Design Change Notice 20104-006, On-Site Disposal Facility Phase IV  
Construction - Addition of Sedimentation Basin #2 to Phase IV Scope of  
Work

(4) RESPONSIBLE DISCIPLINE: E <input type="checkbox"/> M <input type="checkbox"/> C <input checked="" type="checkbox"/> OTHER <input type="checkbox"/>		(4A) RCI/DCN TITLE: Addition of Sedimentation Basin #2 to Phase IV scope of work	(11) DCN NO.: 20104-006

(7) DOCUMENTS AFFECTED		(7) DOCUMENT NOS.	(7) REV.
Phase V Construction Drawing: Subgrade Grading Plan III - Cell 6 Liner System and OSDF Sedimentation Basin No. 2		90X-6000-G-00367	0
Phase V Construction Drawing: Surface-Water Management System Details VII		90X-6000-G-00404	0

TITLE: SURFACE-WATER MANAGEMENT SYSTEM DETAILS VII

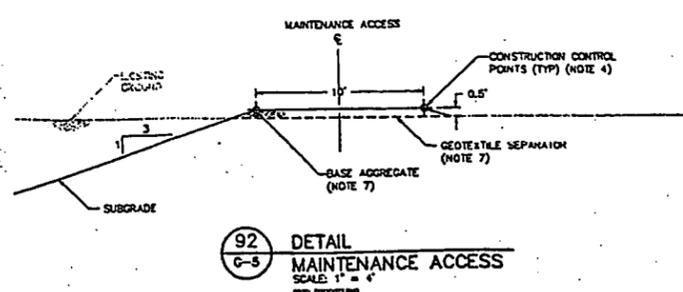
Drawing #: Drawing 90X-5000-G-00404 Pg. #: NA Line #: Note 10 Code: C

Comment: Specification 02930 was not included in the package. This should be similar to the specification 02900 included in the CFC for South Field Phase II Groundwater Infrastructure (drawing) package (dated August 29, 2002) which includes a dry area permanent seed mix (Table 02900-1A), a set area permanent seed mix (Table 02900-1B), and a mix for interim vegetation (Table 02900-2). Specification packages 02714 and 02271 referenced in the drawing were also missing from the package.

Response: In response to Comment No. 3, DOE has transmitted Specification Section 02930 and 02714 via e-mail to Tom Schneider on September 18, 2002.

Action: Specification Section 02271 is provided as an attachment to these responses.
